# Office Action Summary

10/705,273

BROWN ET AL.

## **DETAILED ACTION**

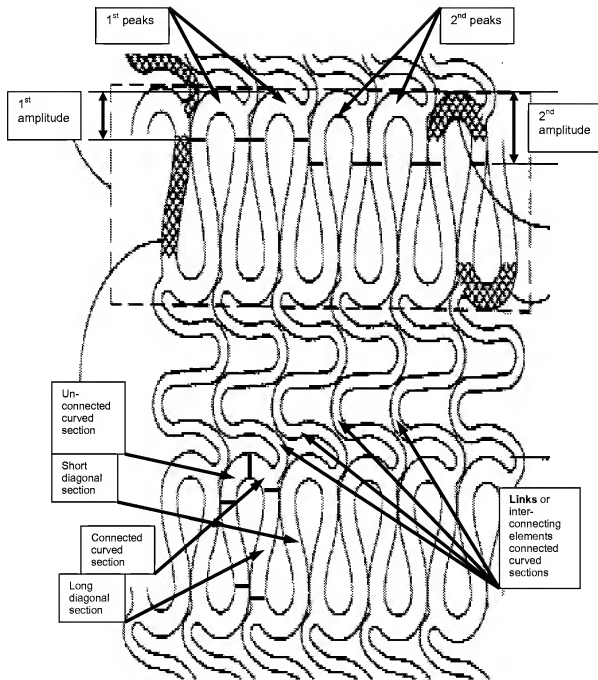
As to claims 38, 42-43, 45, 58-60 and 65, Fischell-'403 discloses a stent made of a stainless steel. Notice that the limitation "short diagonal section", "long diagonal section", "unconnected curved section", and "connected curved section" in the claims are broadly interpreted. Therefore, partial of Fischell-'403's Fig. 9 reproduced below shows each circumferential set of strut members including links 44 connecting "connected curved sections", short diagonal sections, long diagonal section, unconnected curved sections and connected curved sections to define connected strut members and unconnected strut members substantially as recited in the claims.

Notice that there is nothing in the claims to exclude the interpretation of Fischell-'403's Fig. 9 as presented below. The applicant is expected to amend the claims to distinguish the present claimed invention over Fischell-'403's.
